Canberra Pedestrian Forum comments on the Northbourne Avenue bus priority measures and Dickson major bus station feasibility study

Figure 2: Intersection of Northbourne, Macarthur and Wakefield Avenues, showing permitted vehicle flows during the Wakefield Avenue phase.

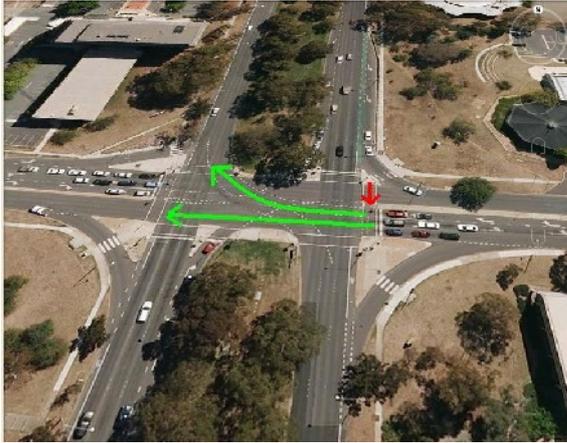
A pedestrian walking towards Civic along Northbourne Avenue, who arrives at the Wakefield Avenue/Macarthur Avenue intersection and presses the pedestrian button before the Northbourne Avenue green phase commences, may legally commence the 20 second Wakefield Avenue crossing at any time during the 55 second green traffic light phase. That is enough time to safely and legally cross, return and cross again.

The pedestrian can also safely cross to the median of Wakefield Avenue during the subsequent Wakefield Avenue straight ahead/right turn phase (Figure 2), when approaching traffic on Macarthur Avenue faces red lights. The pedestrian can safely complete his or her crossing during the Macarthur Avenue straight ahead/right turn phase, when approaching Wakefield Avenue traffic faces red lights.

If the pedestrian presses the pedestrian button one second after the commencement of the Northbourne Avenue green phase, the pedestrian light remains red for the remaining 54 seconds of the green phase, for the entire Wakefield Avenue phase and for the entire Macarthur Avenue phase – even though during these phases the potentially conflicting traffic streams face red lights.

This delay contributes to a high rate of pedestrians choosing to cross either mid-block (31%) or against red pedestrian signals (42%). These crossings are eight times as dangerous as crossing with a green pedestrian signal^{6,7}.
